# Service Information

**Ride:** SEA DRAGON

# SERVICE BULLETIN

SEA DRAGON

## SAMPLE GAUGE INSTALLATION

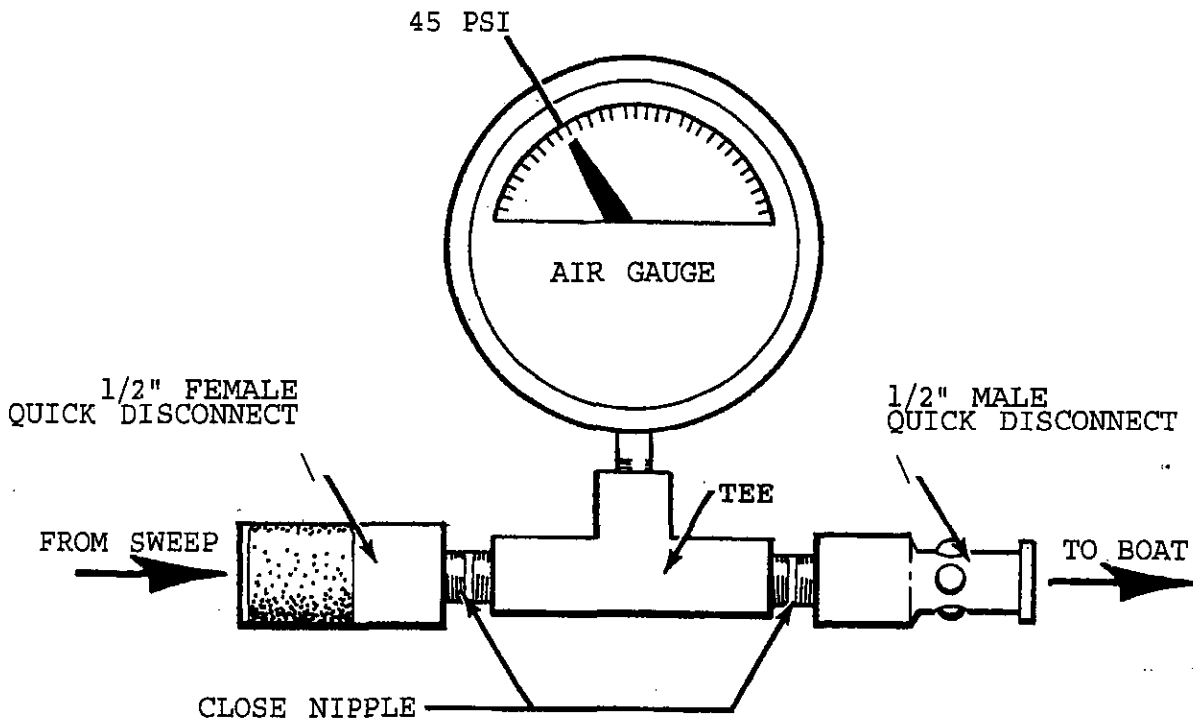
If regulation of air pressure is required the following instructions can be followed in order to determine the air pressure at the boat.

Connect one side of air gauge to the quick disconnect in the back side of the boat. Connect the air line coming down the sweep to the other side of the gauge.

NOTE: Do not operate ride with this gauge connected to the boat. Remove gauge and reconnect air line to boat before operating ride.

NOTE: VIEW EXPLODED FROM BASE

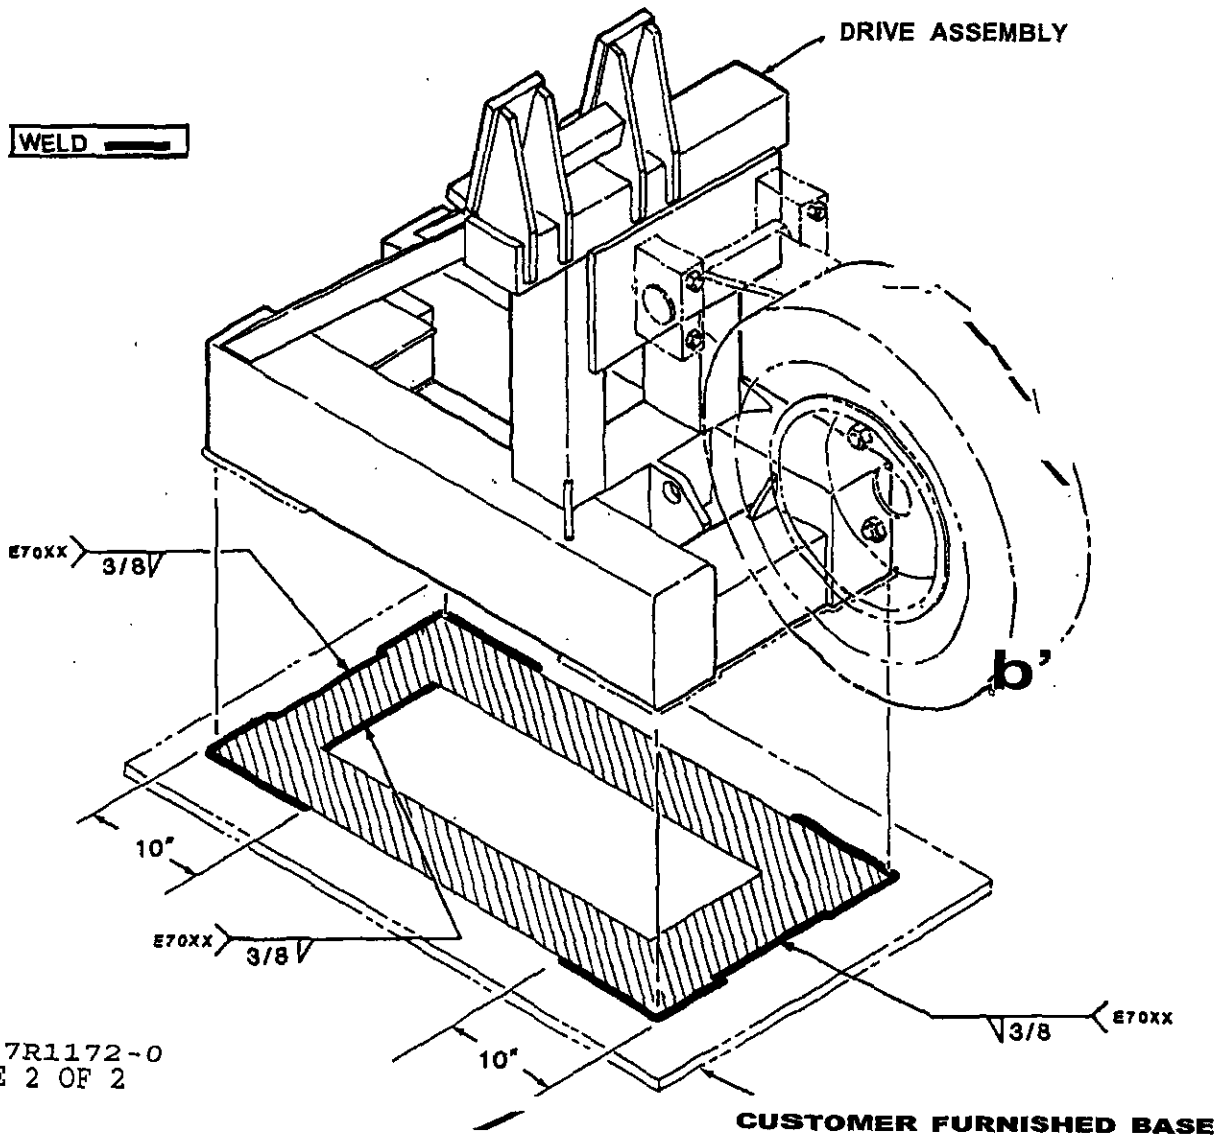
Chance Rides, Inc. has become aware that the drive assembly on some park model SEA DRAGON amusement rides may not be welded adequately. If the drive assembly was not welded adequately to the customer-furnished base plate, damage to the ride and injury to passengers or personnel may occur. This bulletin specifies the minimum length, size and location of weld required to secure the drive assembly.

Chance Rides, Inc. requires all owners of the above noted park model SEA DRAGONS to inspect the welds connecting the drive assembly to the customer furnished base plate. If the weld does not meet the specifications described in this bulletin, DISCONTINUE OPERATION OF THE RIDE. Inspect and weld per the instructions outlined in this bulletin. If you have any questions concerning this procedure, please contact the Chance Customer Service Department at 1-800-CHANCEL.

1. Check to determine if drive assembly has been welded per the specifications shown.
2. Visually inspect existing welds and drive assembly for cracks.
3. If no cracks are found and if the welding does not meet or exceed the specifications shown below, re weld as shown.
4. If cracks are found in existing welds, grind out welds and re weld per the specifications. If cracks are found in the drive assembly structure, contact the Chance Rides, Inc. Customer Service Department.

### Inspection Procedure

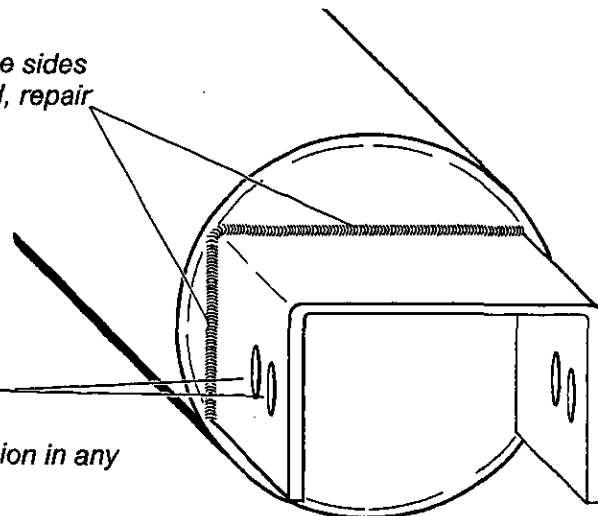
1. Remove the mast base cover to gain access to the mast hinge.
2. Remove the top pin and lower the mast to the roading position. Secure the mast in this position and remove the other pin.
3. Inspect the pin holes for wear as shown. Measure each hole in all directions. If any measurement exceeds 1.150", do not operate the ride with the mast in place until the rework described in this bulletin has been completed.
4. Inspect the existing welds around the outside of all three sides of the hinge as shown. If any cracks are found, do not operate the ride with the mast in place until welds have been repaired and the rework described in this bulletin has been completed.

*Inspect the existing welds on all three sides of the hinge. If indications are found, repair as described in this bulletin.*

*Inspect all four holes for wear.*

*The maximum allowable dimension in any direction is 1.150".*

**Rework Procedure**

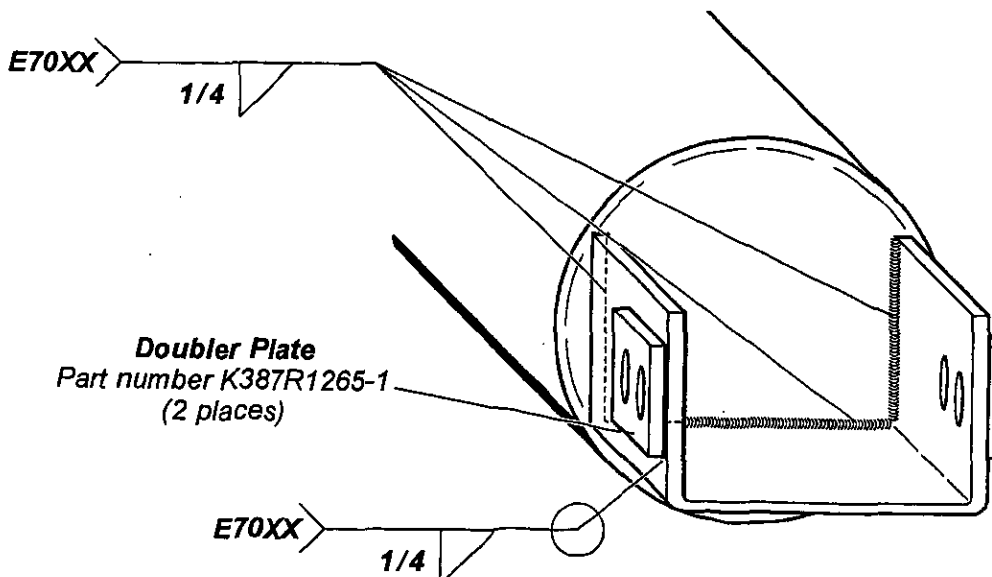
After the mast hinge has been inspected as described, rework as follows:

1. If cracks were found in the existing weld around the outside of the hinge, repair as follows:
  - Completely remove the indication by grinding.
  - Weld using E70XX welding rod.
2. If no cracks were found, or after cracks are repaired, weld the inside of all three sides of the hinge as shown.
3. Locate the doubler plates on the mast hinge and weld as shown. Use the new, longer pins provided in the kit to align the doubler plates.

**NOTE:** Be careful to correctly align the doubler plates, especially if the original holes were excessively worn.
